SUBJECT: September 28, 2021 — Consent Item
Environmental Protection Commission Recommendation for
Request for Waiver and Variance for Steven and Sara
Kachelmeyer Dock Construction Permit BD-20-08-143

BD-20-08-143

DOCK PLANS

Kachelmeyer Boat Dock

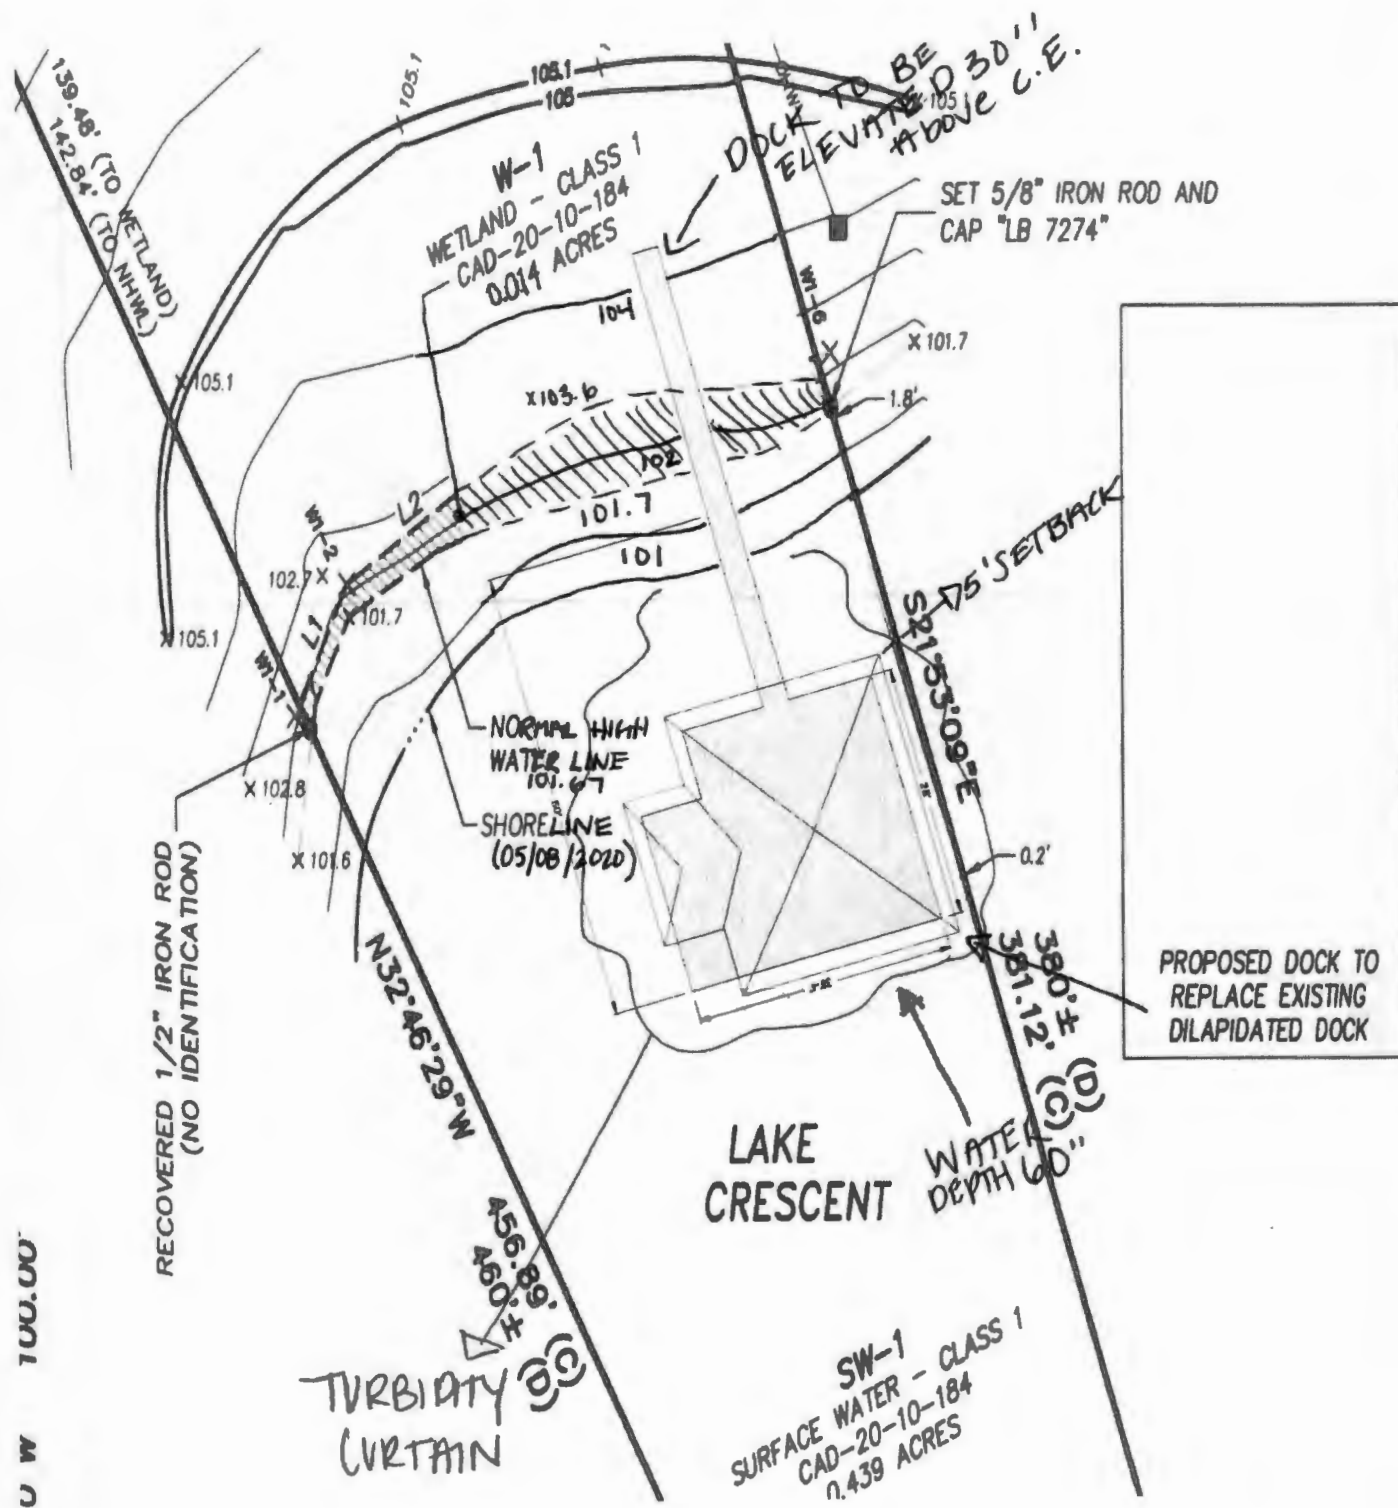
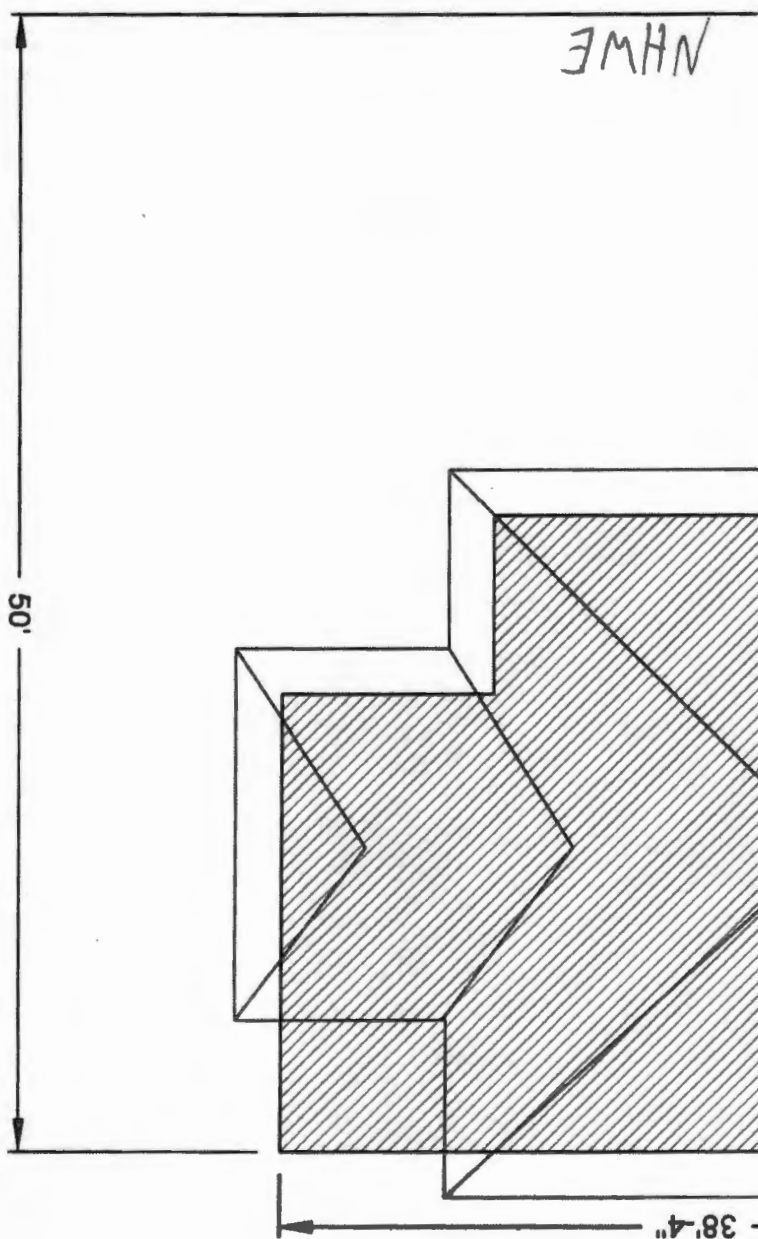
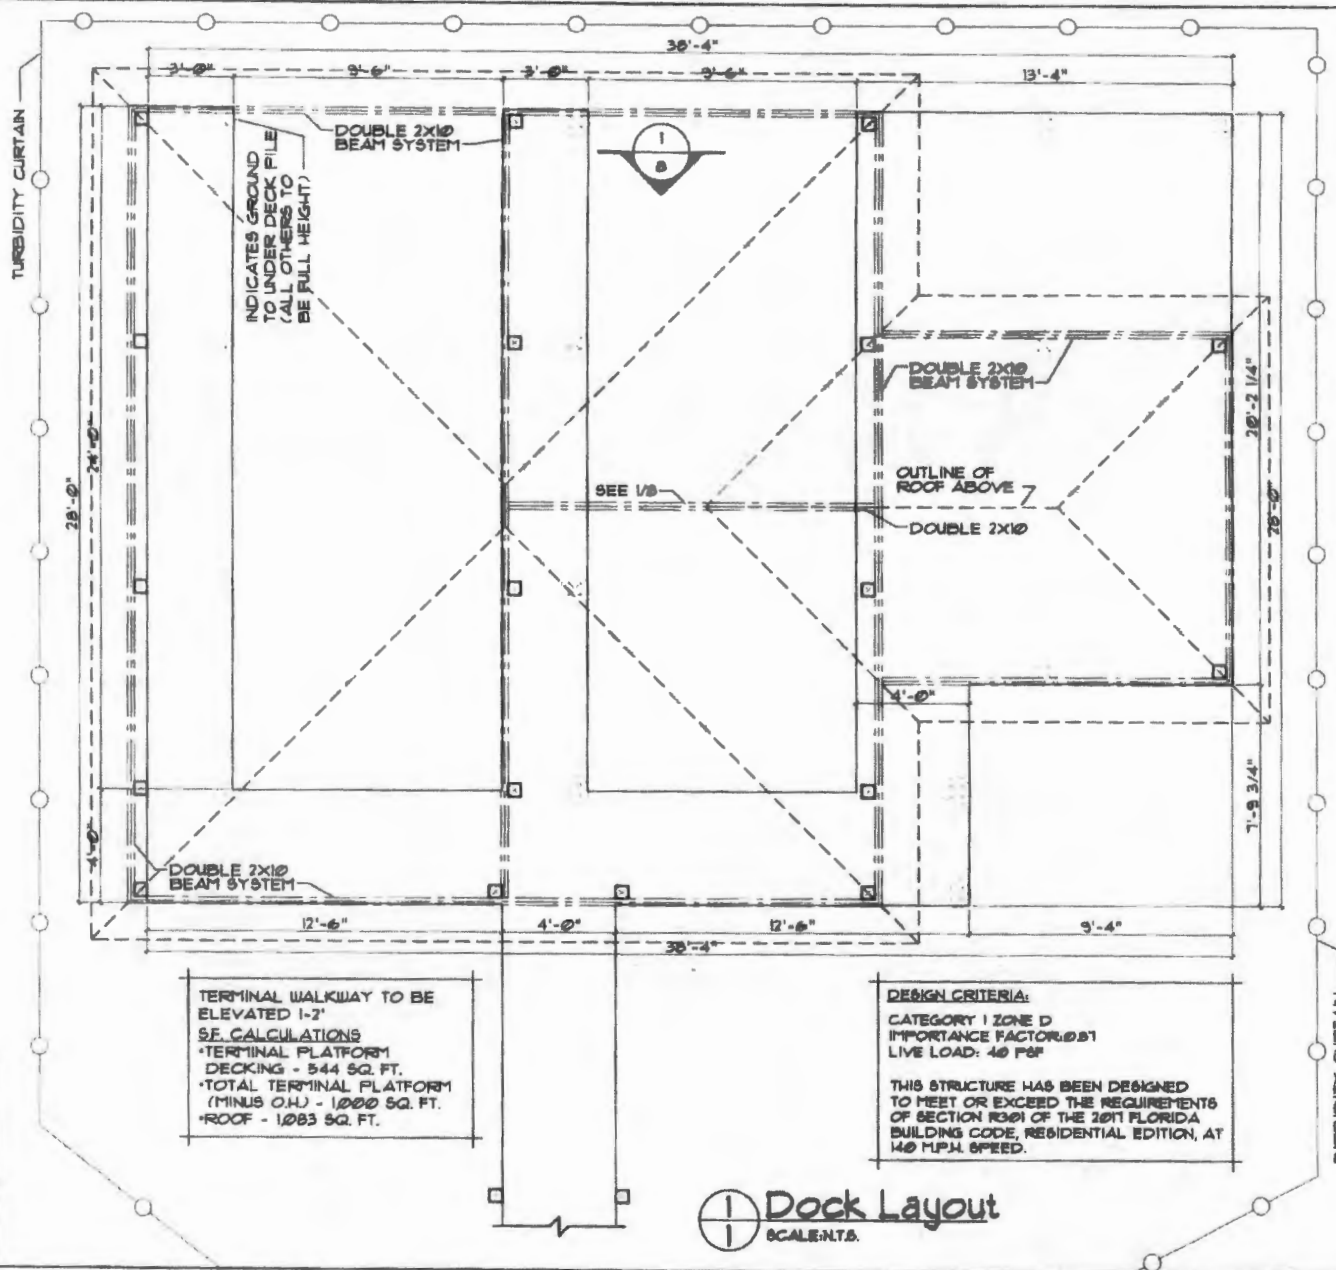
Section 15-342(b) of the Code states, "the maximum square footage of the terminal platform shall not exceed the square footage of ten times the linear shoreline frontage for the first seventy-five (75) feet of shoreline and five times the linear shoreline frontage for each foot in excess of seventy-five (75) feet, not to exceed a maximum of 1,000 square feet." The applicants have a shoreline that measures approximately 107 linear feet at the Normal High Water Elevation, allowing for a maximum terminal platform size of 910 square feet. The applicants are requesting a terminal platform size of 1,000 square feet (90 square feet larger than allowed).

Section 15-342(c) of the Code states, "Access walkways traversing any wetland shall be elevated a minimum of three (3) feet above the ground surface." The applicants' property contains a wetland that the proposed dock will traverse. The applicants are requesting to elevate the access walkway 30 inches over the wetland area in lieu of the required 36 inches minimum height above the ground surface.

EPD evaluated the waiver and variance requests for compliance with the criteria for approval in Code and based upon the criteria in 15-350, the recommendation of the Environmental Protection Officer (EPO) was to approve the request for waiver to Section 15-342(b) (terminal platform size) based on a finding that the applicant had demonstrated that there will be no effect from the proposed waiver on abutting shoreline owners pursuant to Section 15-350(a)(2)(2), as no objections have been received, and pursuant to Section 15-350(a)(2)(1), negative effects to the environment from additional shading due to the excess in terminal platform size will be offset through the payment of \$675 to the CTF as mitigation.

However, the recommendation of the EPO was to deny the request for variance to Section 15-342(c) (access walkway height) based on a finding that the applicant had not demonstrated that the request would impose a unique and unnecessary hardship that is not self-imposed pursuant to Section 15-350(a)(1)(1).

Acceptance of the findings and recommendation of the Environmental Protection Commission and approval of the request for waiver to Section 15-342(b) to increase the allowable terminal platform size from 910 square feet to 1,000 square feet with the condition that the applicants pay \$675 to the Conservation Trust Fund within 60 days of the decision of the Board of County Commissioners; and denial of the request for variance to Section 15-342(c) to reduce the required minimum access walkway height from 36 inches to 30 inches over wetlands for the Steven and Sara Kachelmeyer Dock Construction Permit BD-20-08-143. District 1

Square Footages
SCALE: N.T.S.

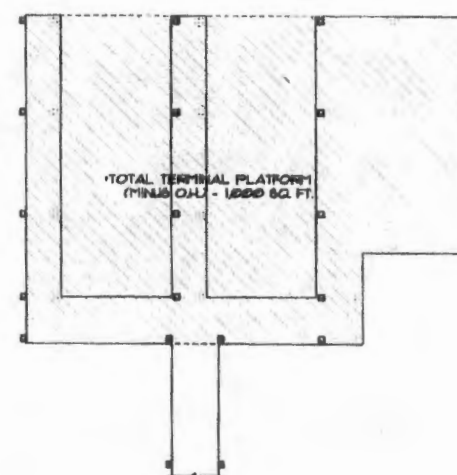
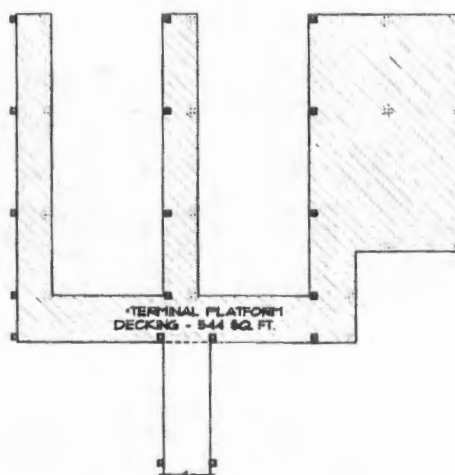
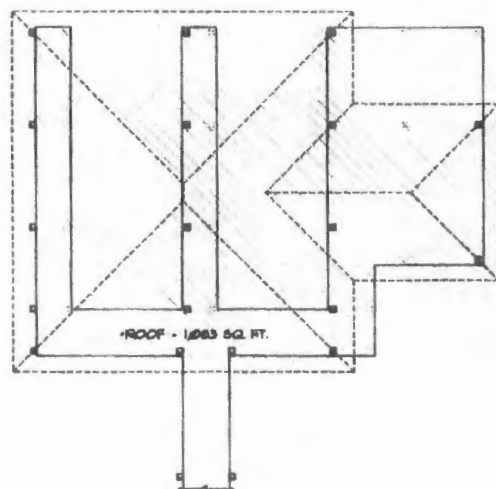
The additional shading impacts from the larger-than-allowed terminal platform were evaluated by EPD staff using the Uniform Mitigation Assessment Method. The applicants have agreed to provide mitigation for the additional shading with a payment of \$675 to the Conservation Trust Fund (CTF).
